Access Compliance Report

Public Rights-of-Way

(Curb Ramps)

Intersection ID: 48196	Main Street: BLAKENEY_PARK_DR	Cross Street: REA_RD	Location:	E
ADA ID: A937EC2B0BF5	Ramp Type: PerpDiag	Initial Pass/Fail: Fail	Overall Compliance: No	Severity Score: 22.5
Codes/Mitigation Info/Possible Solution		Field Measurements/Component Compliance

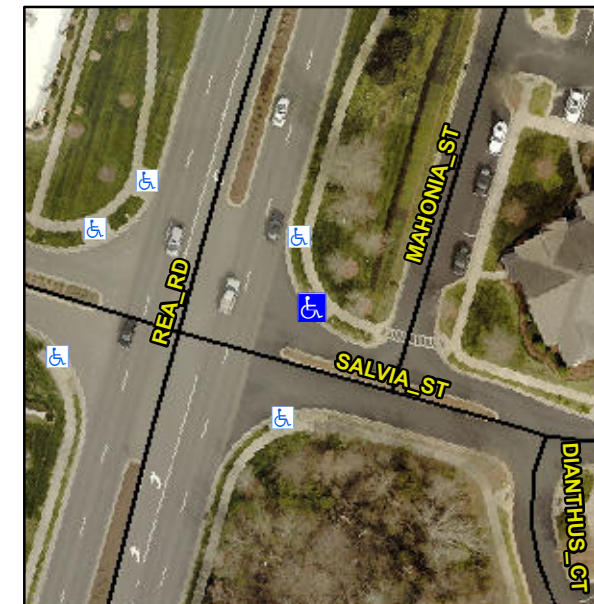
Not Found, R304.5.1, R304.2.2, R304.5.3

Compliance	Description	Data	Compliance	Description	Data
N/A	Ramp Length (in)	76.0	No	Ramp Slope (%)	9.5
No	Ramp Width (in)	42.0	No	Ramp XSlope (%)	2.5
N/A	Flare Type LT	N/A	N/A	Flare Type RT	N/A
N/A	Flare Slope LT (%)	N/A	N/A	Flare Slope RT (%)	N/A
N/A	Flare Traversable LT?	N/A	N/A	Flare Traversable RT?	N/A
N/A	Landing Length (in)	N/A	N/A	DWS Provided?	N/A
N/A	Landing Width (in)	N/A	N/A	DWS Contrast?	N/A
N/A	Landing Slope (%)	N/A	N/A	DWS Length (in)	N/A
N/A	Landing X Slope (%)	N/A	N/A	DWS Full Width?	N/A
N/A	Landing Curb? (Y/N)	N/A	N/A	DWS Offset (in)	N/A
N/A	Shared Landing?	N/A			
N/A	Gutter Ponding?	N/A	N/A	Gutter Slope (%)	N/A
N/A	Gutter Lip Ht (in)	N/A	N/A	Gutter X Slope (%)	N/A
N/A	Painted X Walk1?	No	N/A	Painted X Walk2?	No
	X Walk 1 Direction	To NW		X Walk 2 Direction	To SW
N/A	X Walk 1 Width (in)	N/A	N/A	X Walk 2 Width (in)	N/A
	X Walk 1 Slope (%)	4.6		X Walk 2 Slope (%)	2.3
	X Walk 1 X Slope (%)	0.7		X Walk 2 X Slope (%)	1.6

Remove & Replace Curb Ramp With Two New Directional Ramps or Equivalent.
